**ZONING AMENDMENT,
PLANNED UNIT DEVELOPMENT &
SUBDIVISION STAFF REPORT**

Date: March 1, 2012

Broad Palmetto Subdivision

202 South Broad Street
(West side of South Broad Street, 55'± South of Palmetto
Street and extending West to the South side of Palmetto
Street, 130'± West of South Broad Street).

SITE PLAN

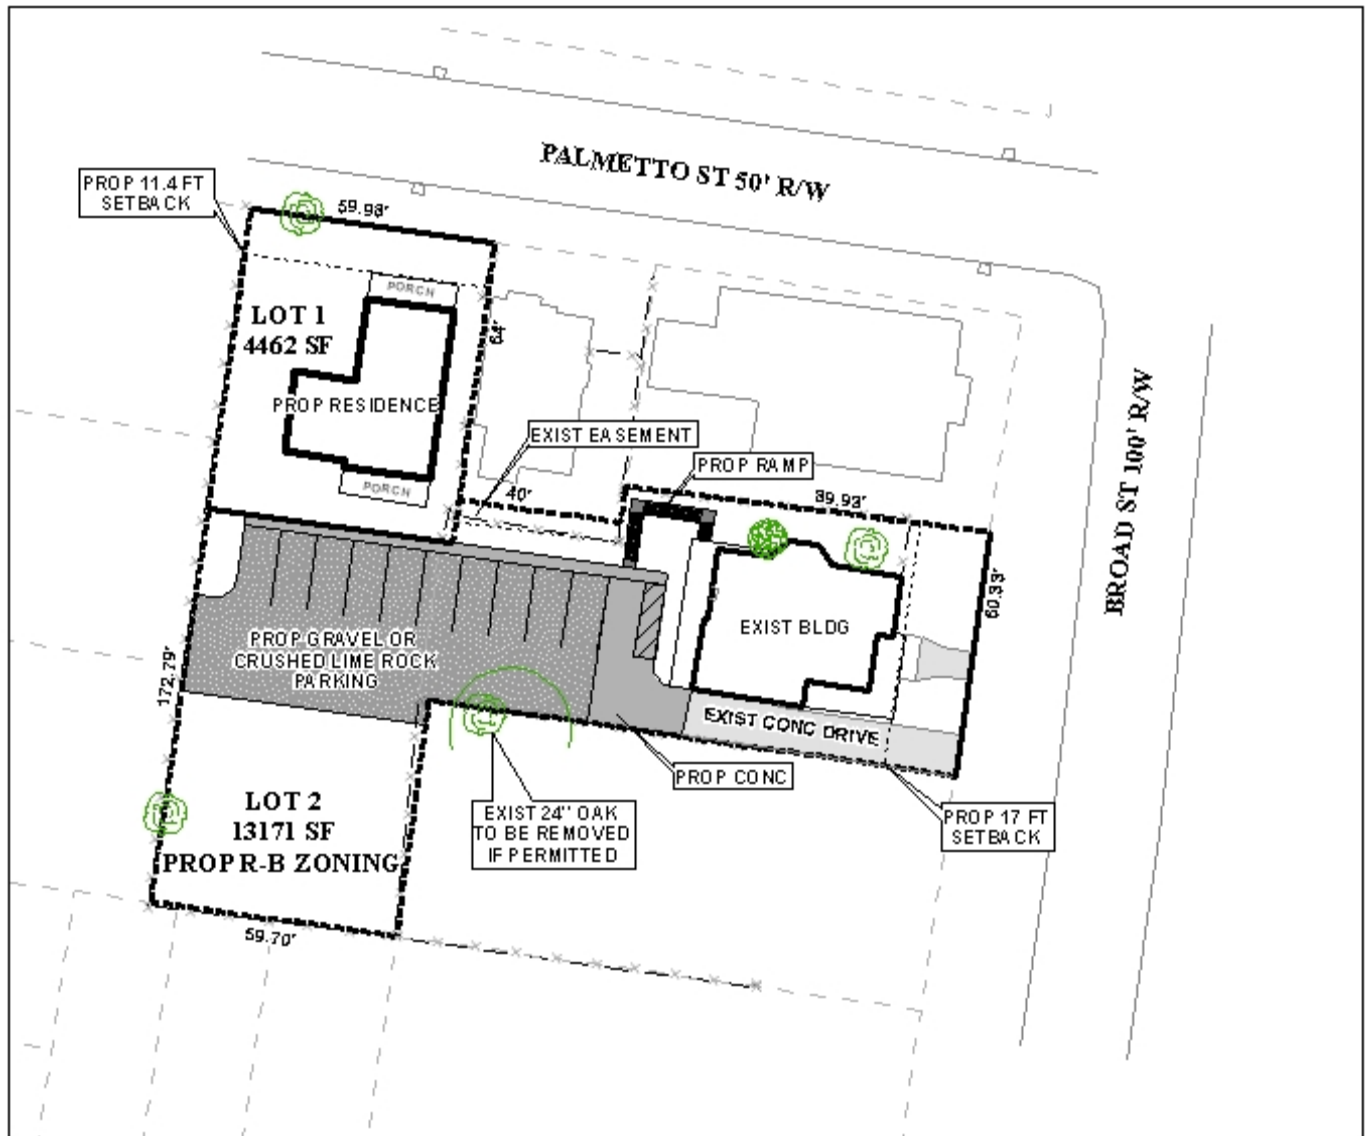
In this case, the site plan submitted by the applicant does not depict the required improvements on the site, including buffers, dumpster locations, and landscaping. It should be noted, that if the proposed Lot 2 is rezoned, as requested, that the applicant will be required to provide a protection buffer of 10' as well as either a 6' high privacy fence or 10' wide screen planting strip no less than 6' in height at time of planting and consisting of evergreen vegetation alongside all adjacent R-1, Single-Family Residential properties.

Also, there is no depiction of a dumpster or note provided to determine if the applicant will comply with Section 64-4.D.9. of the Zoning Ordinance.

The only landscaping illustrated on the site plan are existing trees, some of which appear to be located either in the right-of-way, or on adjacent properties, and no landscape calculations are provided. It appears that the proposed Lot 2 may not have the required amount of frontage landscaping available. Also, the site plan indicates that there is an existing 24" oak tree that appears to be on the property to the immediate South of the proposed Lot 2 and is noted as to be removed pending the release of Urban Forestry permits. The site plan states that if removal of the tree is not granted, that the area of root coverage may prohibit commercial development of the site.

There are several issues of concern with the parking area as illustrated. First, the site plan illustrates gravel or crushed limestone for surfacing of all parking and maneuvering area with the exception of one handicapped space. The applicant states it is their understanding that gravel and crushed limestone are commonly required in historic districts, however, Section 64-6.A.3.a. states that all parking areas must be paved with concrete, asphaltic concrete, asphalt, or alternative parking surface, with the only exception being I-2, Heavy Industry Districts and sites located in the Henry Aaron Loop, which does not include the subject property. Engineering and Traffic Engineering have also included in their comments that the illustrated surfacing would not be ideal or approved by either department. Also, it appears that the handicap space provided does not meet ADA van accessible requirements and according to Traffic Engineering comments, proposed walkways and ramps on the site may not meet ADA codes either. If approved, this would place a commercial parking lot in the middle of a primarily residential block, surrounded completely by residences in a historic district which will increase traffic, light, and noise experienced by the adjacent property owners.

The applicant depicts an existing 10.5' curb-cut and a driveway that ranges from 10.5' to 11.9' for Lot 2 to access the proposed parking on the rear of the site. This is considerably less than the minimum 24' width required for two-way traffic, and is slightly less than what would typically be accepted for one-way traffic. It should be noted, it may not be feasible for the applicant to provide a larger driveway to access the rear of the property; however, the rezoning of the site to allow commercial development may create an unsafe access environment. Traffic Engineering comments discuss how conflicting movements would cause vehicles to either backup 100' within the site, or onto Broad Street where traffic is rounding a sharp curve. The proposed parking and maneuverability design would result in conditions that are not in support of the primary purpose of the Zoning Ordinance as stated in Section 64-1.A, in that it may increase traffic congestion on public streets, and could result in dangerous conditions that would threaten the health and general welfare of the citizens of the City of Mobile.

The site plan does not illustrate a driveway for Lot 1, which may damage the existing 36" oak tree which appears to be located in the right-of-way, and is located to the East of the illustrated proposed residence.

The site plan submitted does not depict the existing sidewalks along Broad Street and Palmetto Street. In addition, any required storm detention is not depicted on the site plan.
